re Indian Residential School, Lebret.

re Qu'Appelle Indian Residential School. Lebret.

Qu'Appelle Indian Residential School, Lebret.

INDIAN RESIDENTIAL SCHOOL
LEBRET, SASK.

DETAILS OF PIPING
FOR
WATER SUPPLY SUCTION MAIN
AND
PUMP HOUSE ADDITION DRAINAGE

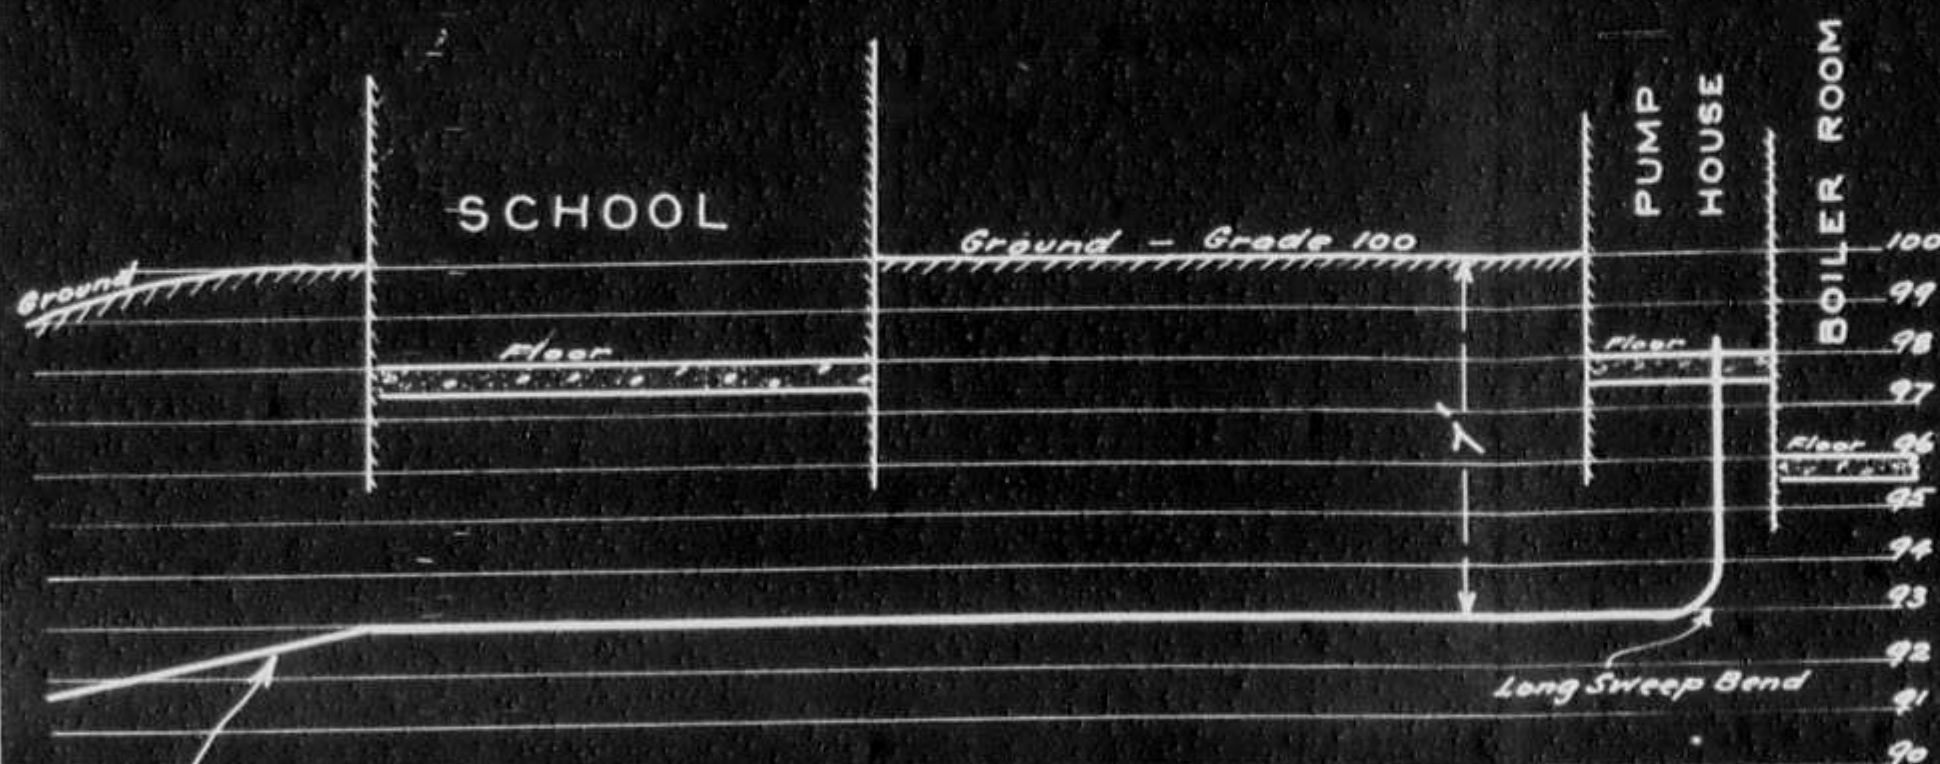
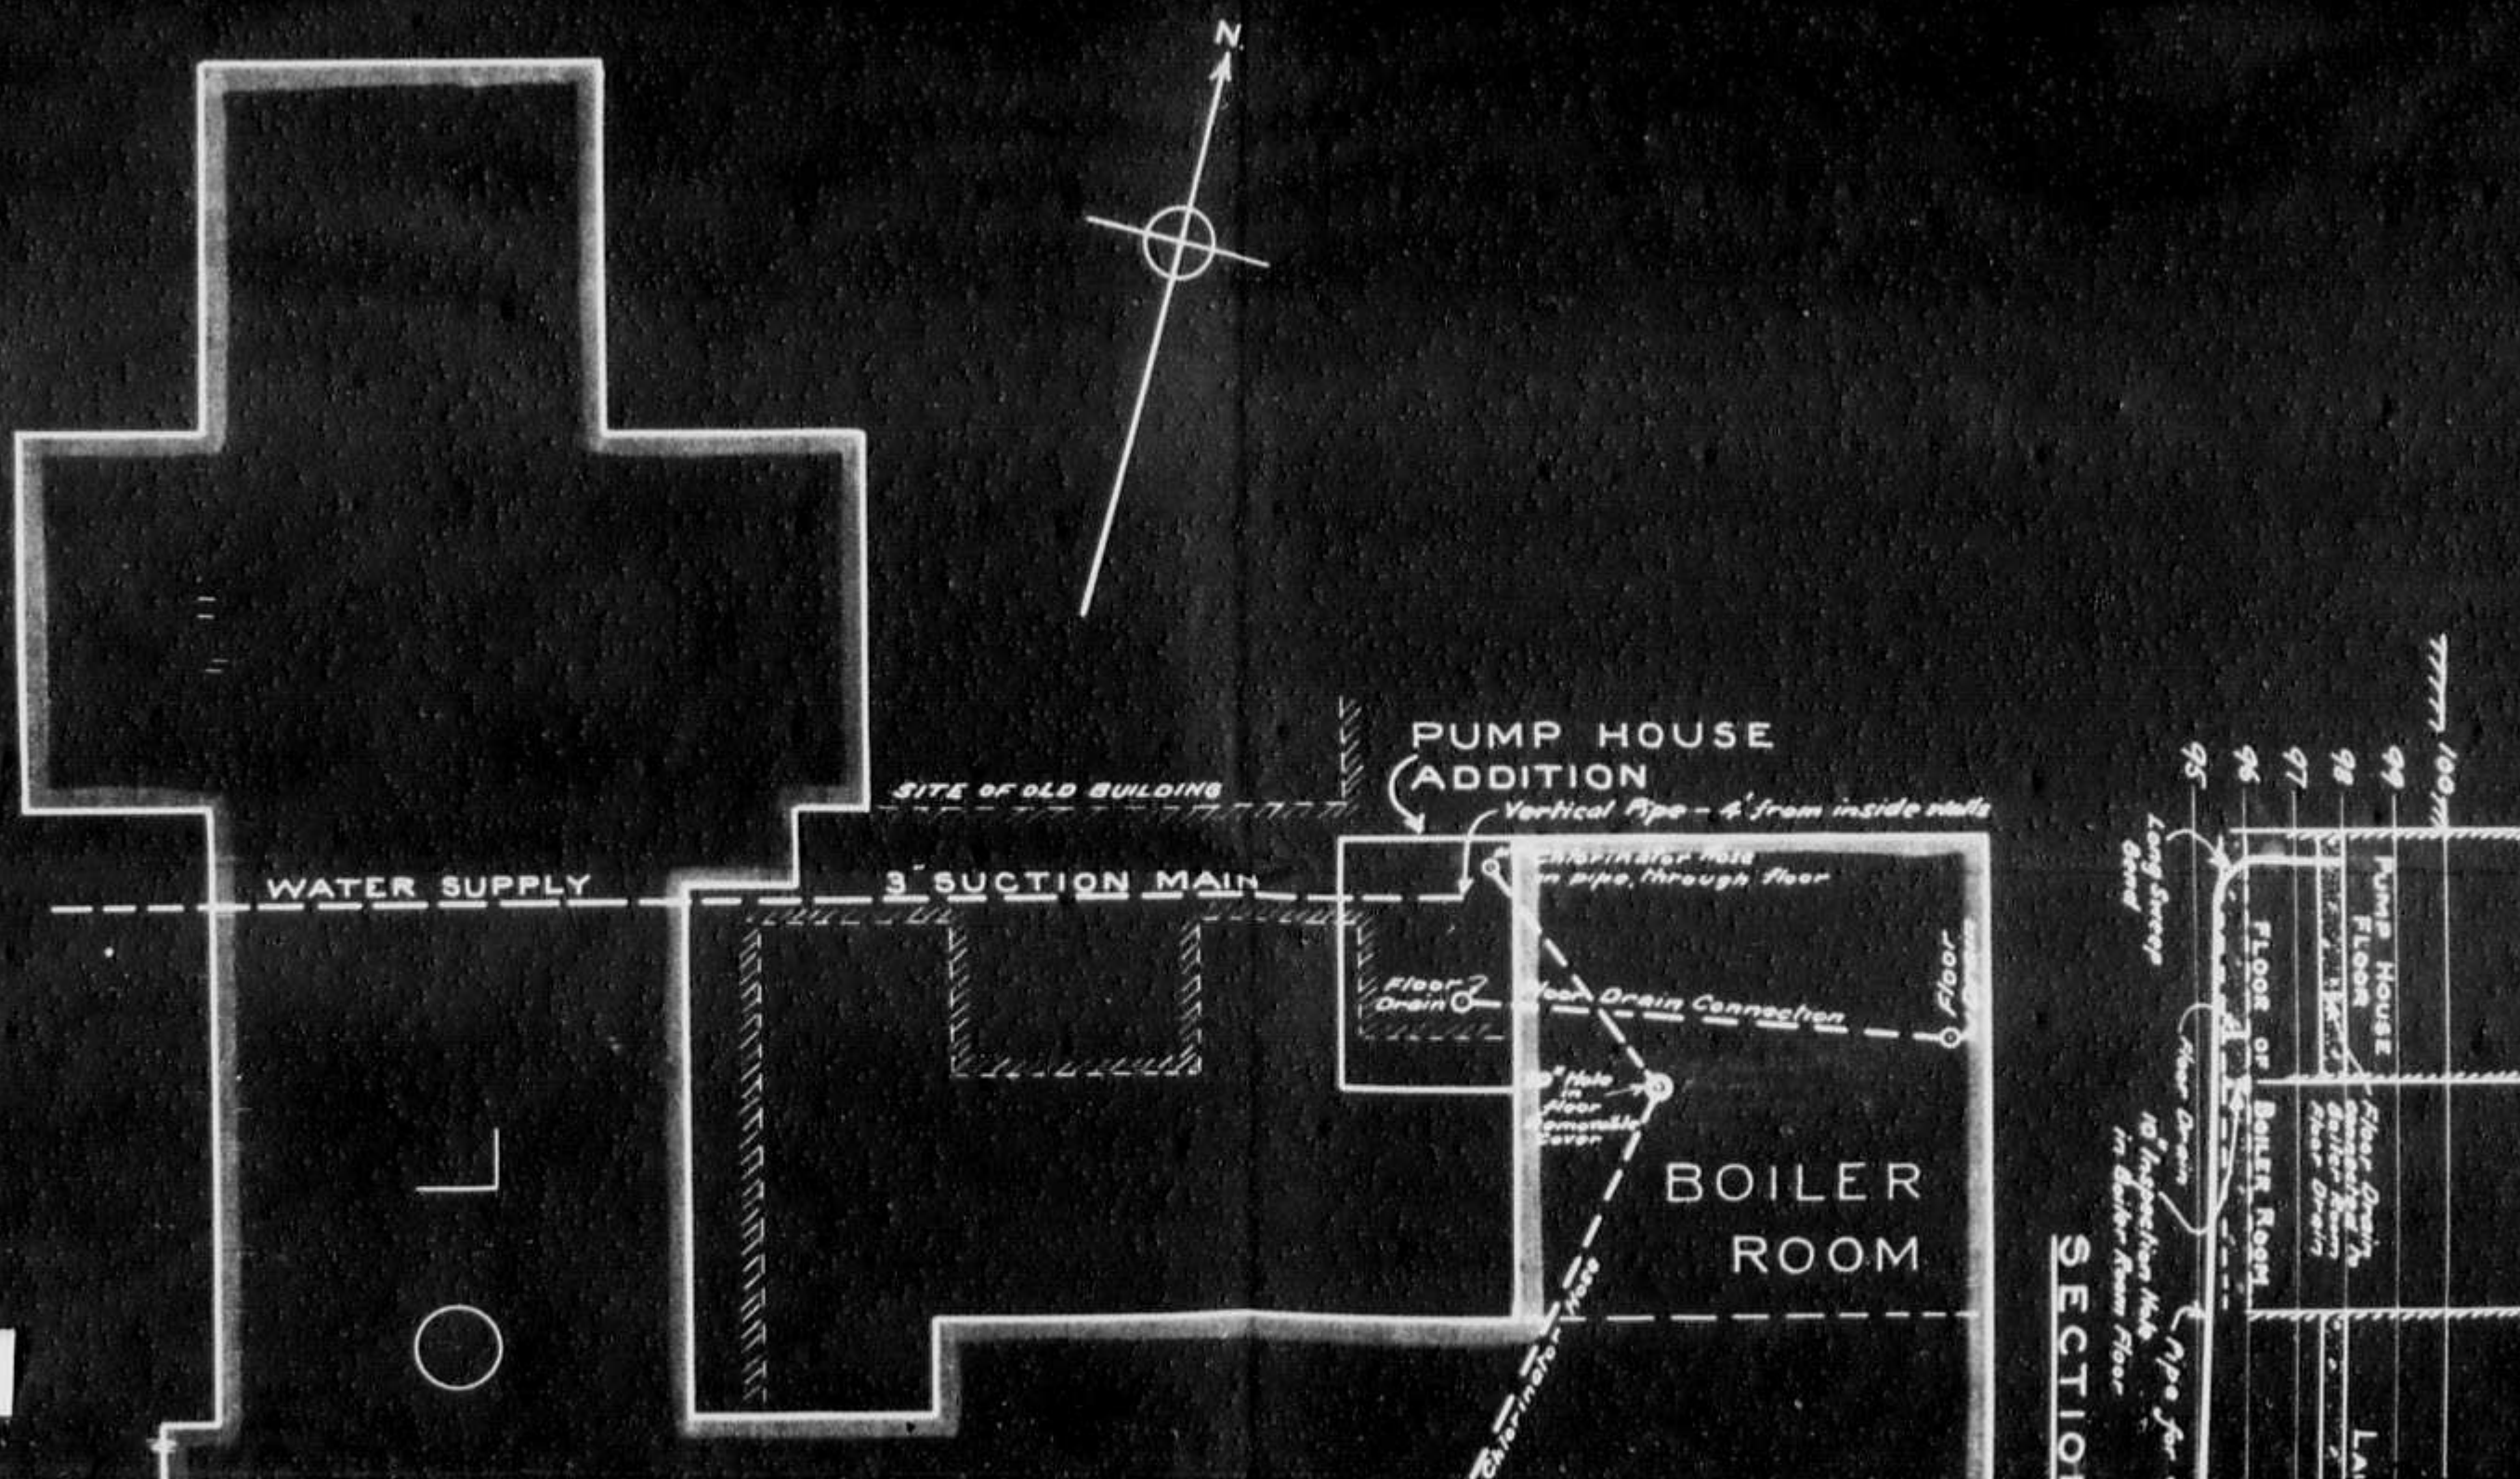
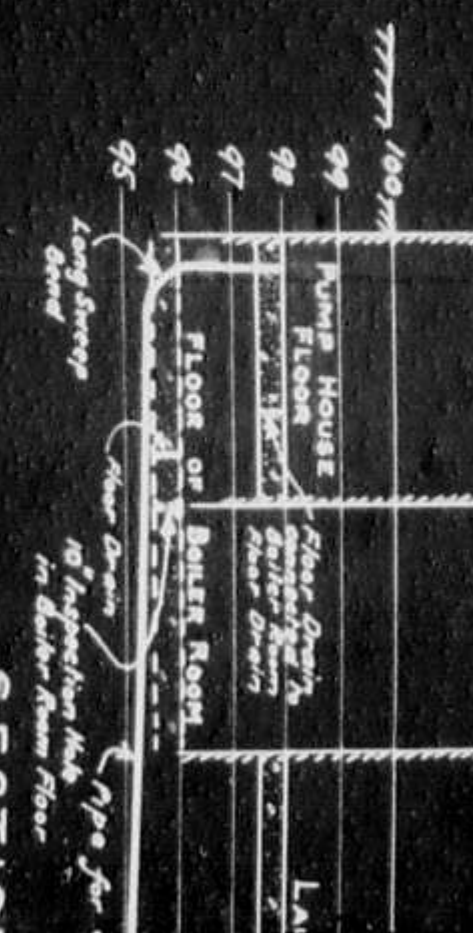
Enclosed you will please find in duplicate a blue print showing the details of the proposed piping for the water supply suction main and also the pipes and drains for the pump house addition, also outside storm water pipe connection and the outside sewer connection for the Qu'Appelle Indian Residential School at Lebret, Saskatchewan.

The general plan shows the addition authorized to the school to house the pumping plant and auxiliary equipment required in connection with the water supply. The plan also shows the proposed location of the 3" suction main water supply pipe line from the pump house addition to the westerly limits of the school building. There is also shown the location of the proposed floor drain connection between the floor drain in the pump house addition and the floor drain as shown on the general school plans in the boiler room. This drain is necessary to provide drainage for flushing the pump house floor and also to care for waste from the water softener which it is proposed to install. We have shown the proposed location of a 2" cast iron pipe leading from the chlorinator to its connection with the storm water drain at the south portion of the laundry. The rubber tubing to carry the waste from the chlorinator will be passed through this 2" pipe as it is essential that the chlorine solution does not come in contact with any metal piping. The blue print also shows the proposed drains outside of the building to connect between the sewerage pipe in the school and the septic tank and also between the storm water pipe in the school and the outlet towards the creek.

This blue print also shows a profile of the water supply suction main from the pump room to a point beyond the westerly boundary of the school building. It will be observed that it has been necessary to keep this main at least seven feet underground to prevent trouble from frost. Another section shows the 2" pipe for the chlorinator hose from the point where it leaves the chlorinator to its junction with the roof drainage pipe at the southerly side of the laundry portion of the building. This section shows the pipe with reference to the floor of the boiler room and laundry room floor.
